**DRAINAGE REPORT**

**PROJECT: 22A267**

**PCD File No. PPR2325**

**Town of Ramah Wastewater  
System Improvements**

## DRAINAGE PLANS

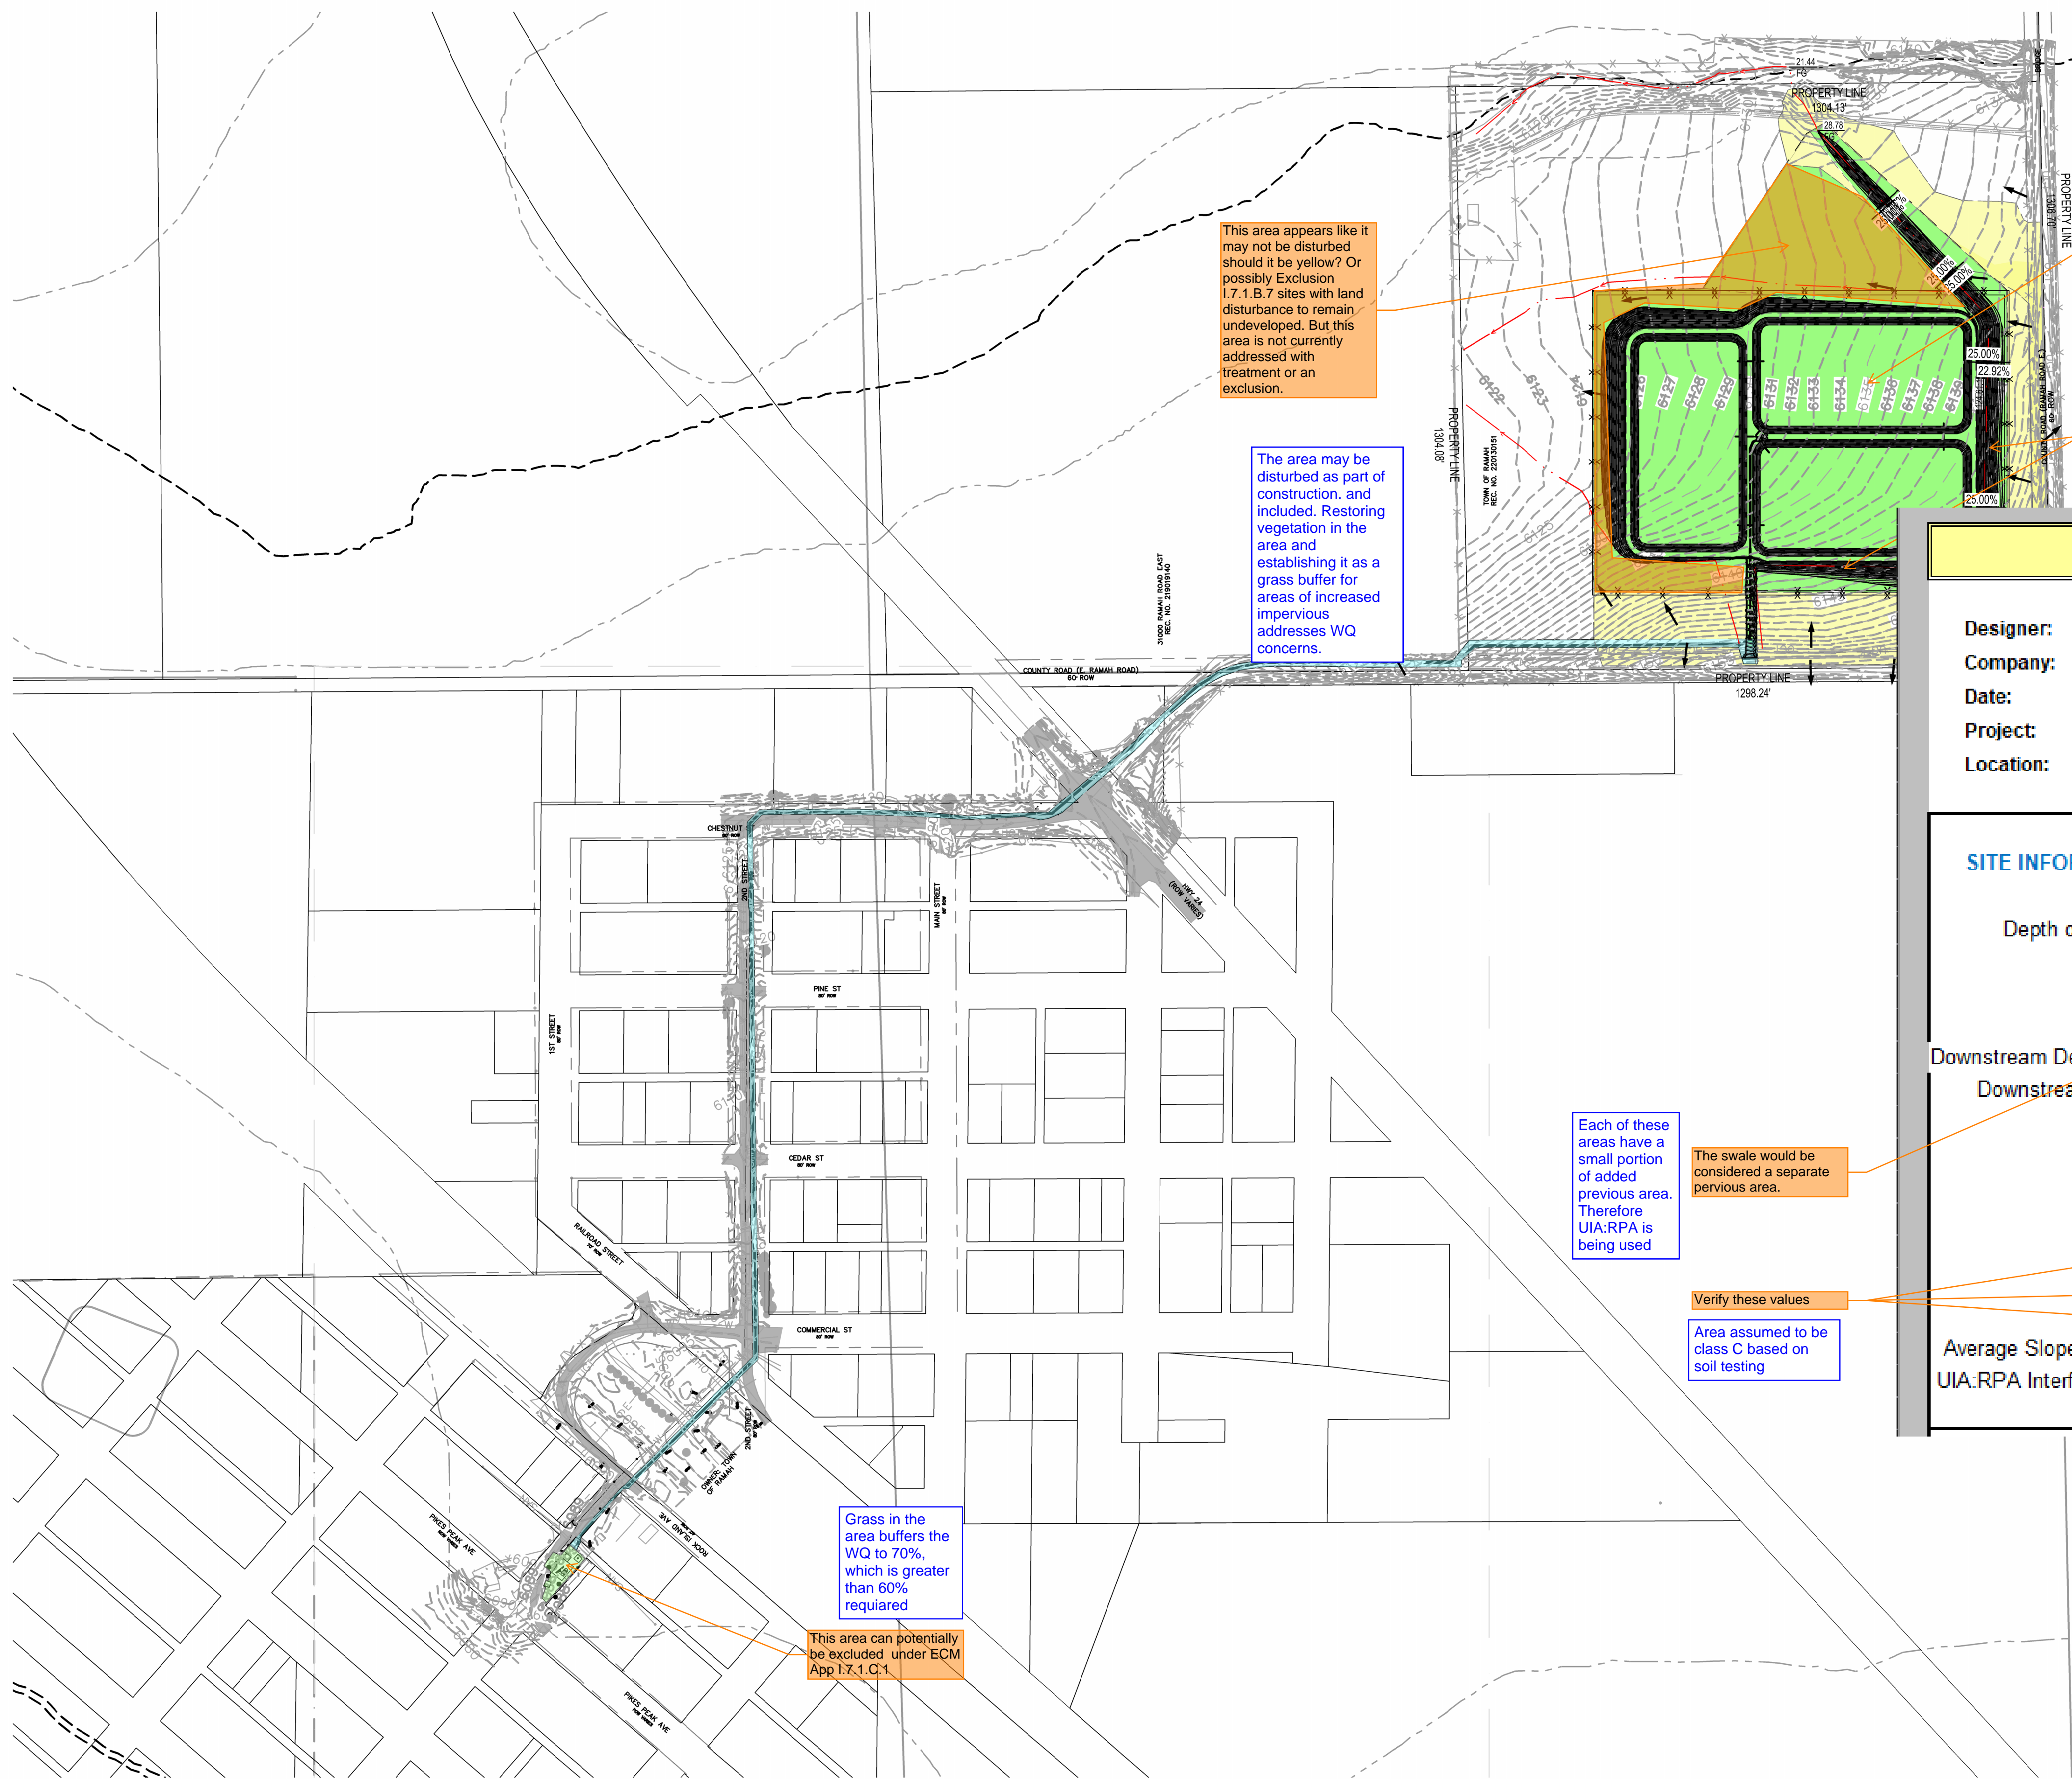
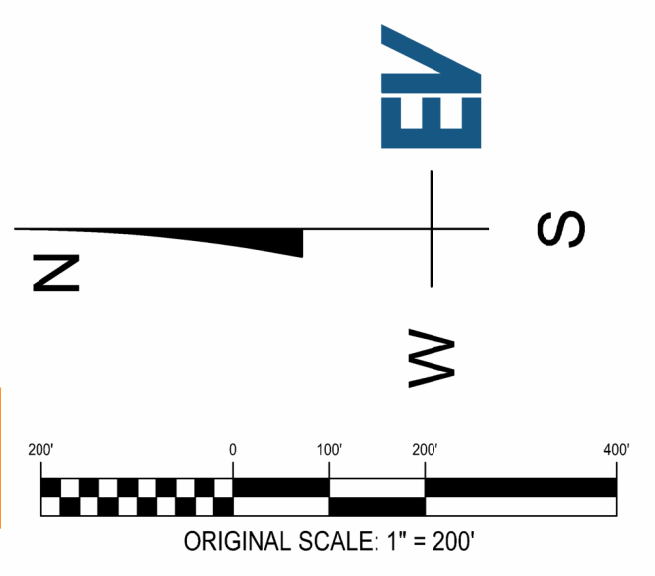
Identify the three evaporation ponds as utilizes the runoff reduction standard.

changed the legend name to Runoff Reduction
